STATE OF FLORIDA DEPARTMENT OF TRANSPORTATION

2010 Interim Design Standard

PRECAST SOUND BARRIERS - PILE AND POST REINFORCING STEEL

Index No.: 5205

PILE/POST CONNECTION OPTION A

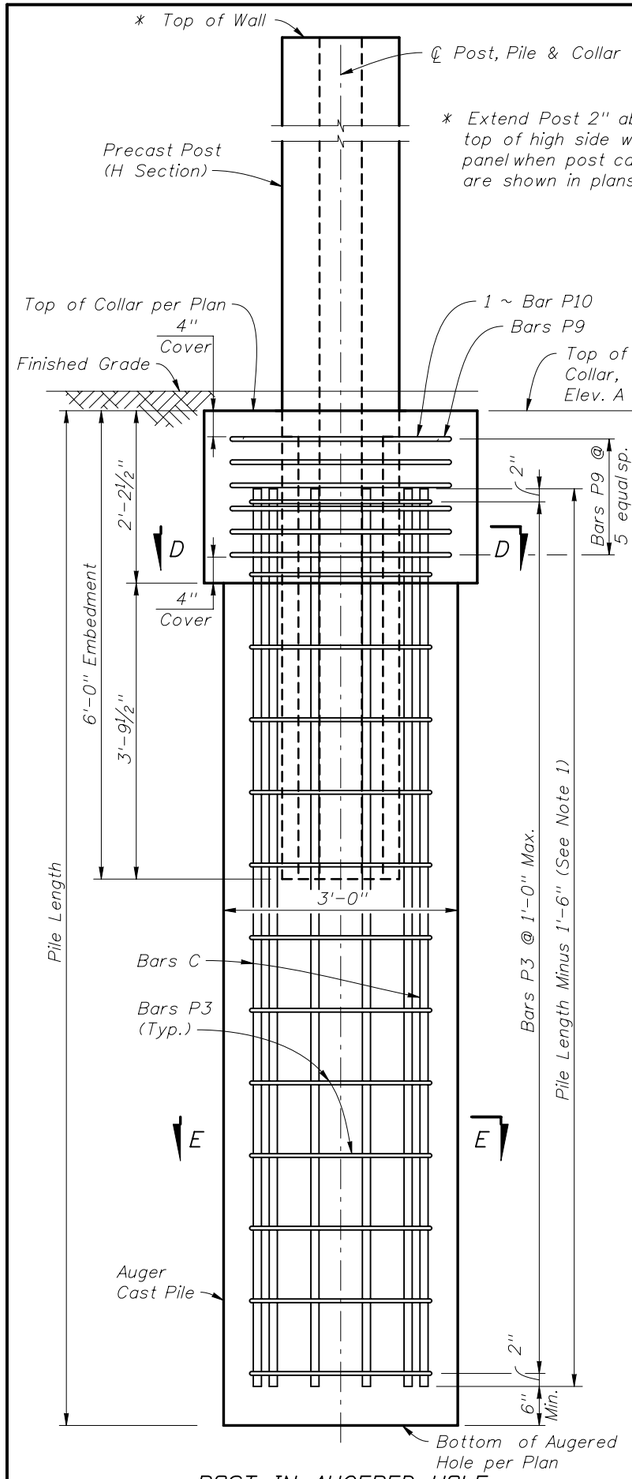
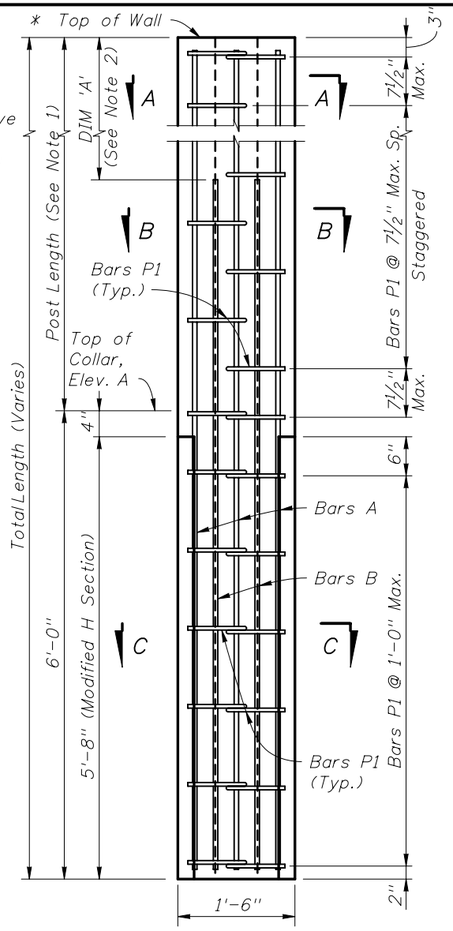
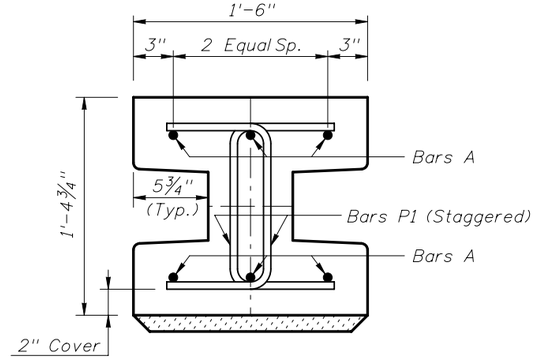
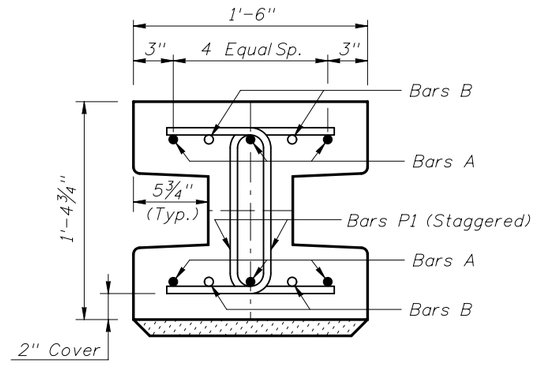
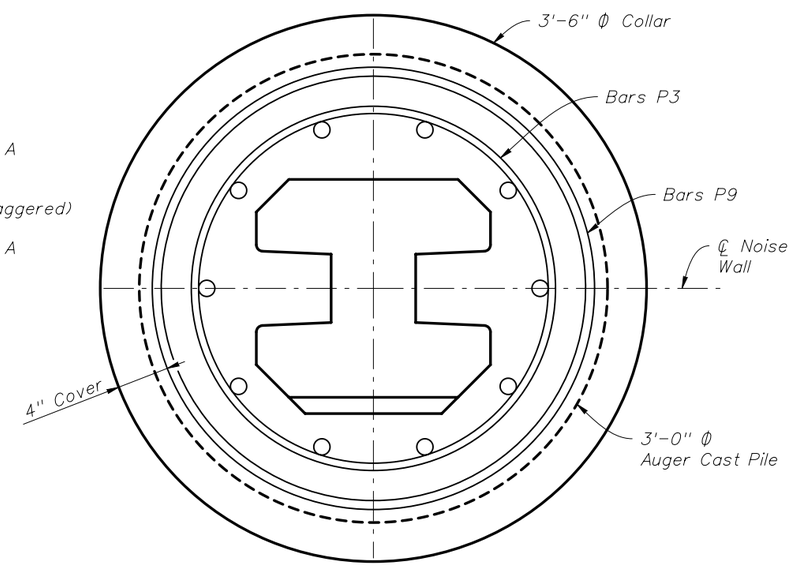
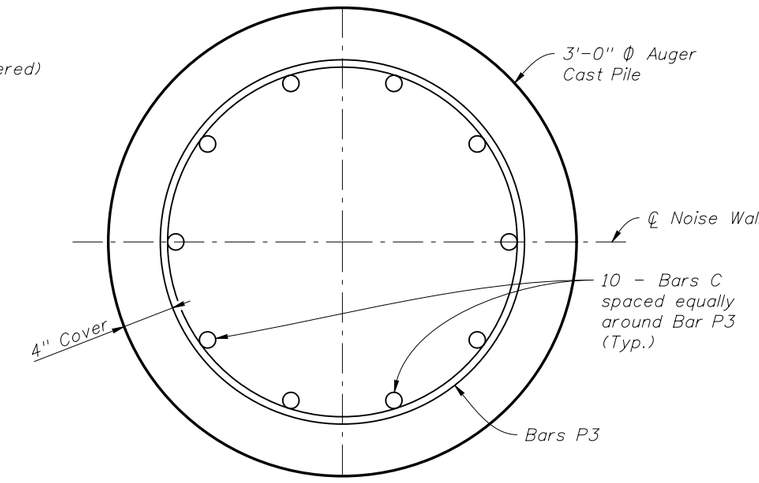
REVISIONS					
DATE	BY	DESCRIPTION	DATE	BY	DESCRIPTION
01/01/10	SJN	Side cover in auger cast piles changed to 4"; Sheet redrawn and Sections renamed.

PRECAST COLLAR FOR PILE/POST CONNECTION OPTION A

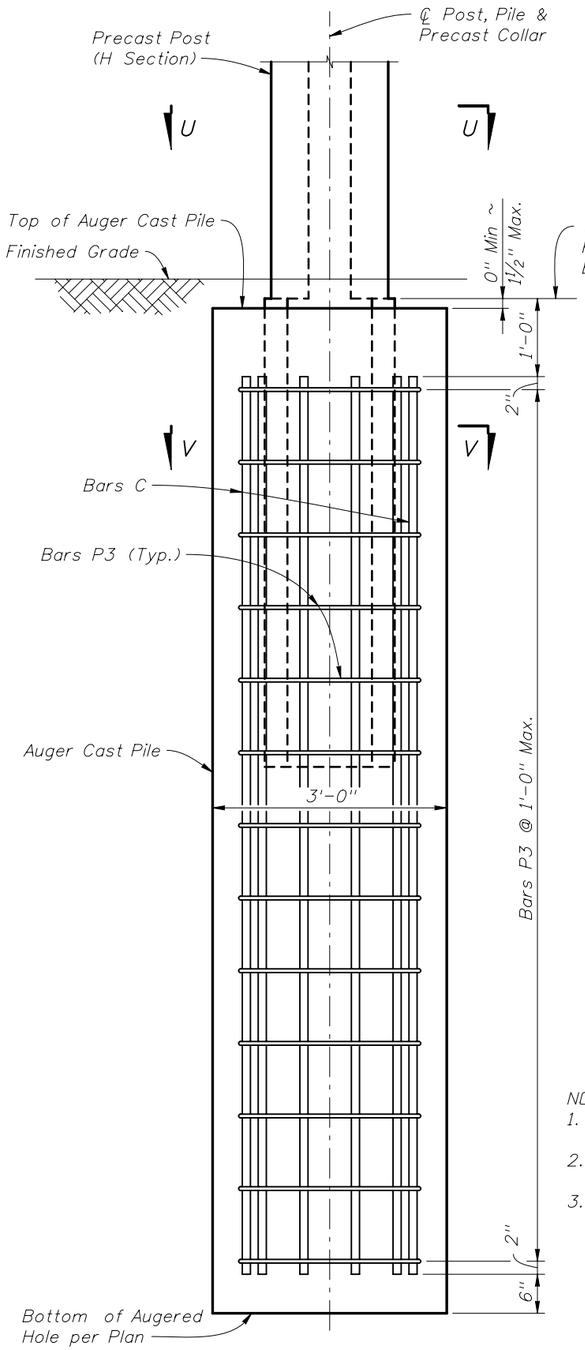
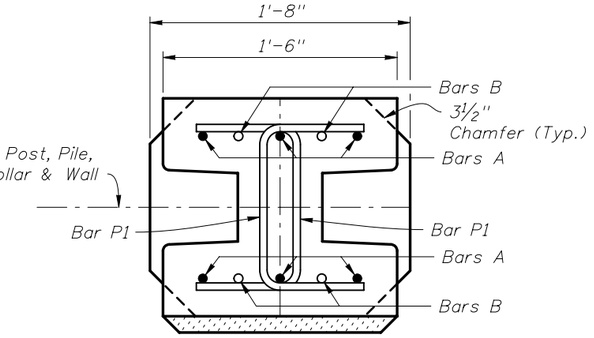
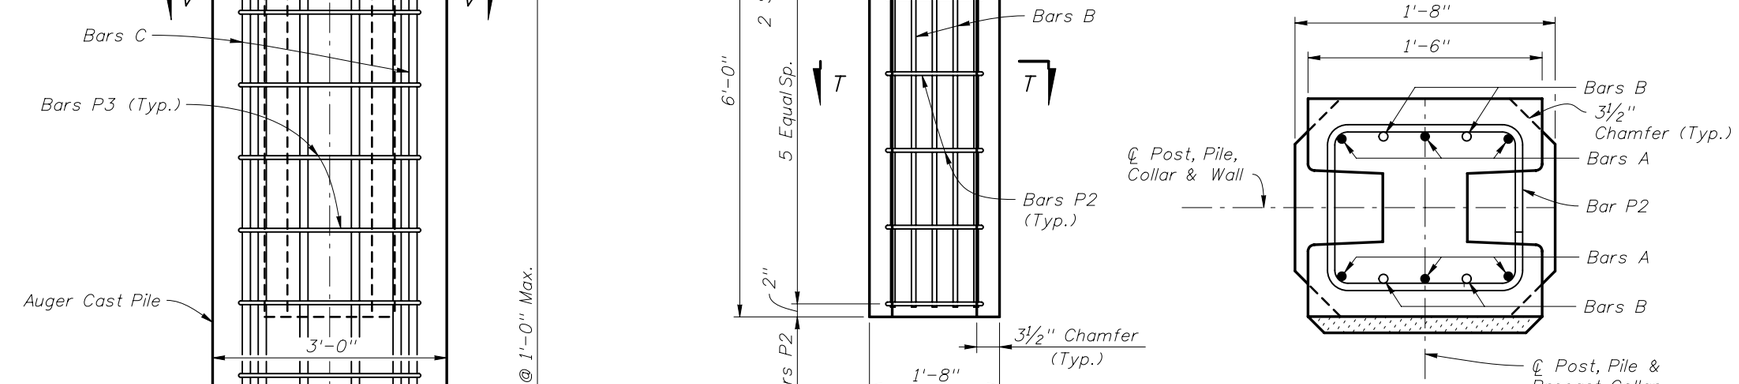
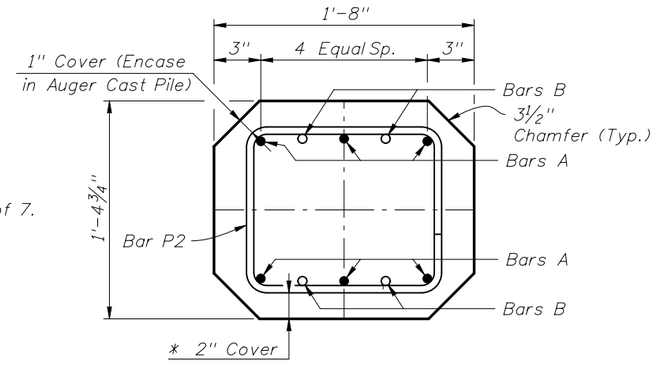
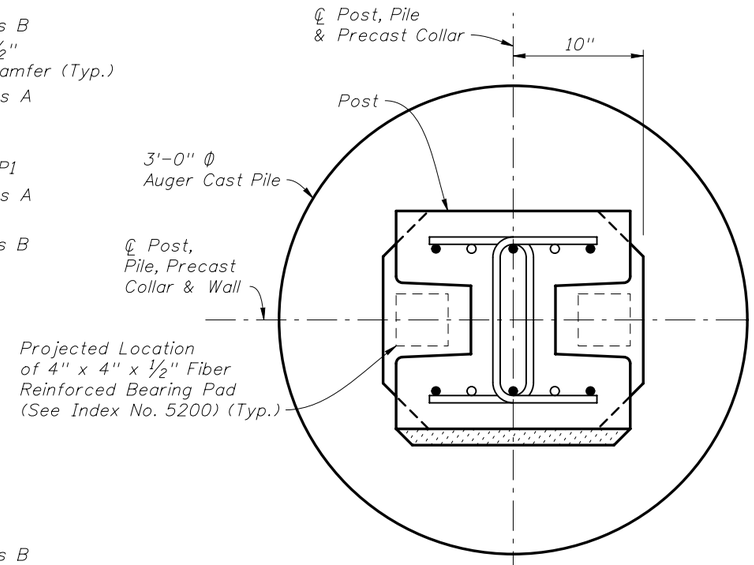
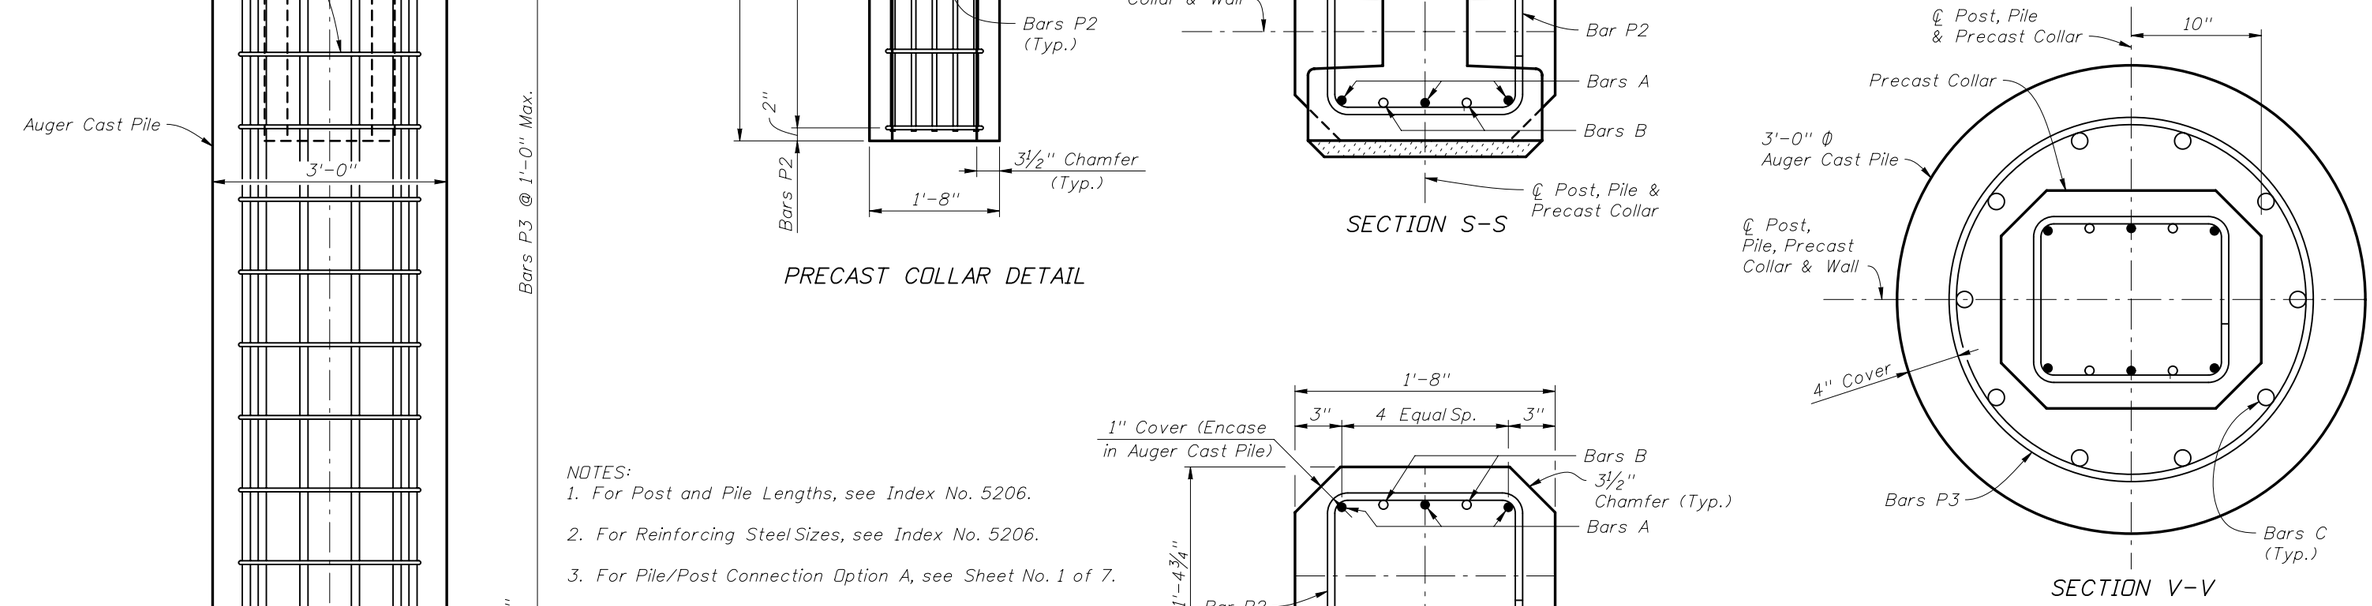
REVISIONS					
DATE	BY	DESCRIPTION	DATE	BY	DESCRIPTION
01/01/10	SJN	Side cover in auger cast piles reduced to 4"; Sheet redrawn and Sections renamed.

PILE/POST CONNECTION OPTION B

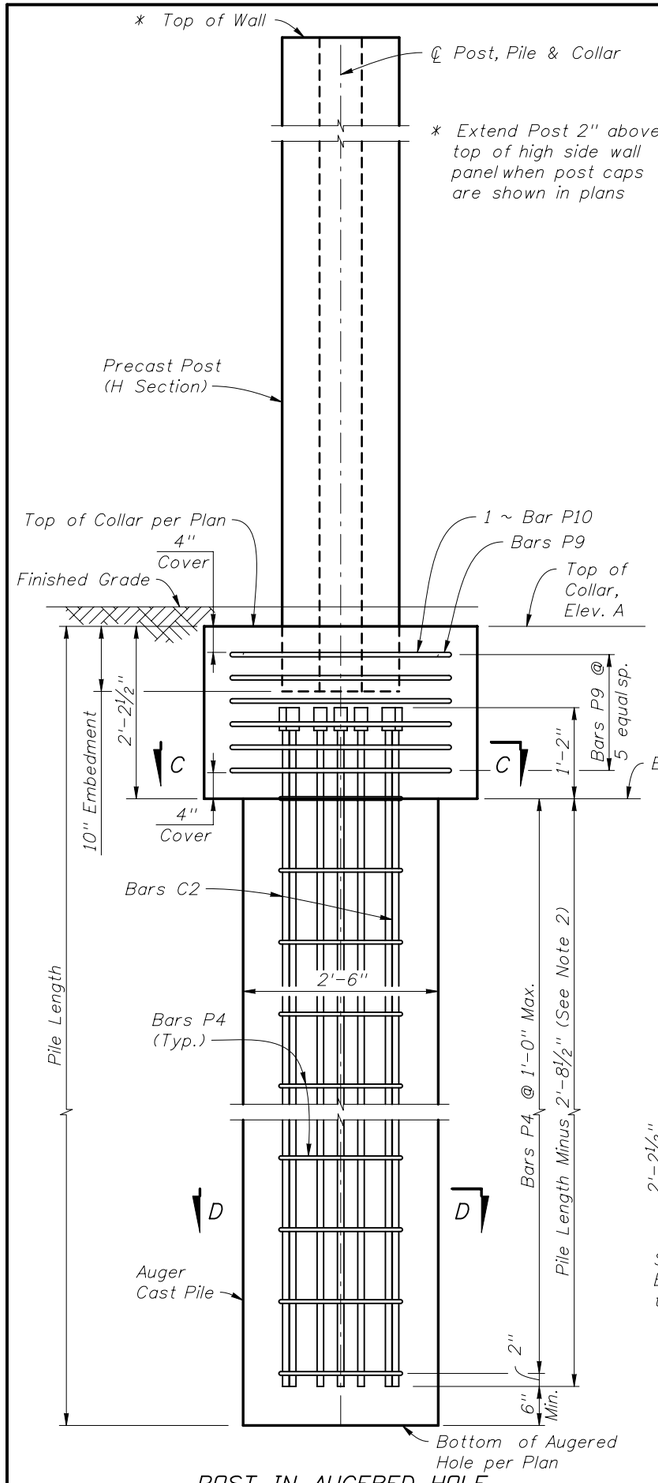
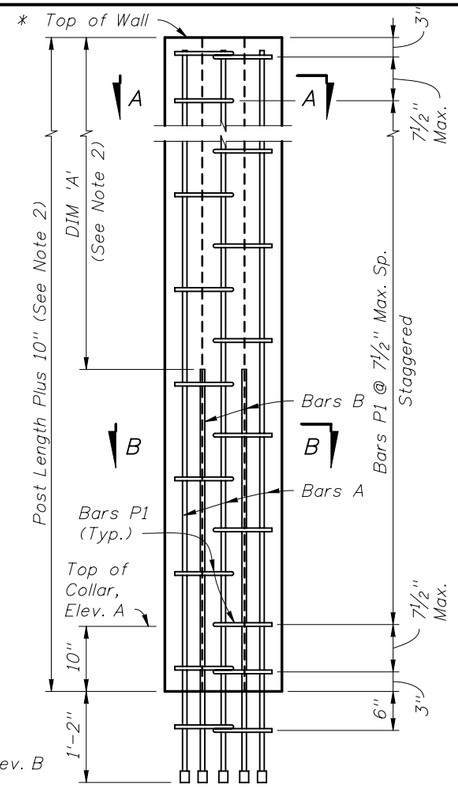
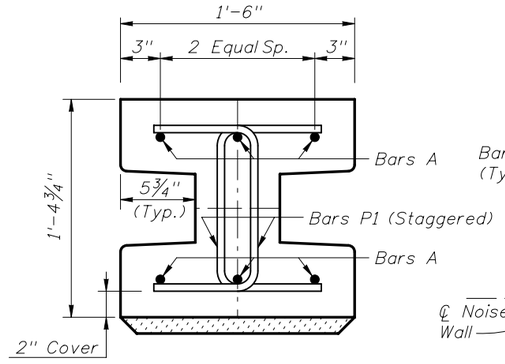
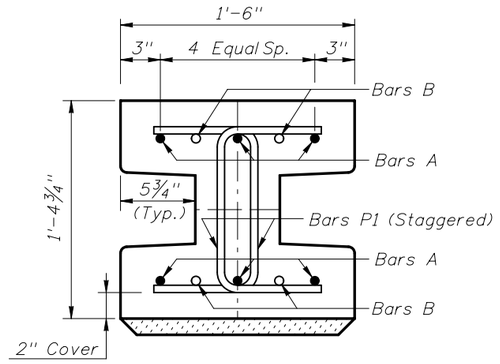
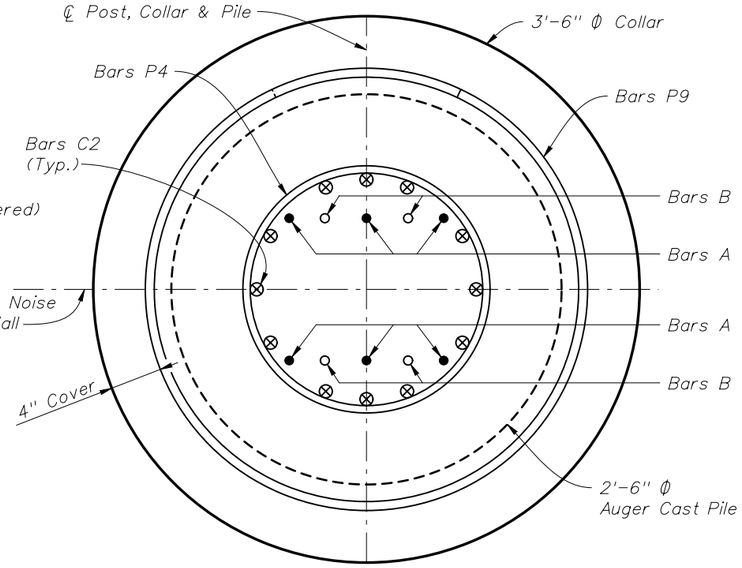
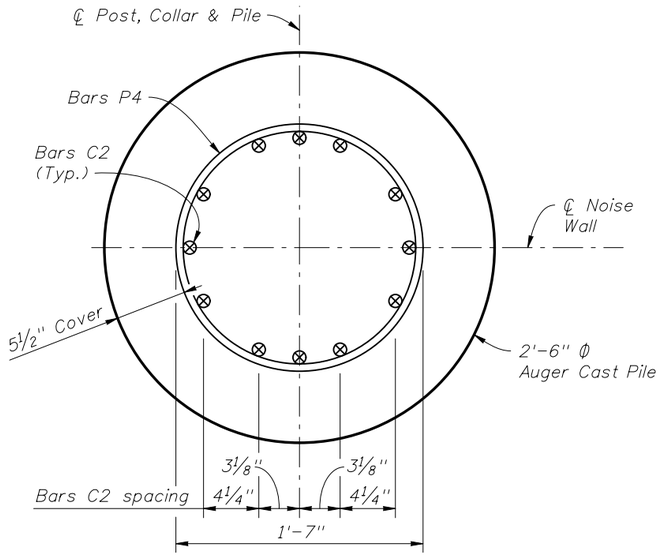
DATE	BY	DESCRIPTION	DATE	BY	DESCRIPTION
01/01/10	SJN	All details redrawn. Removed AUGERED PILE REINFORCEMENT DETAIL.
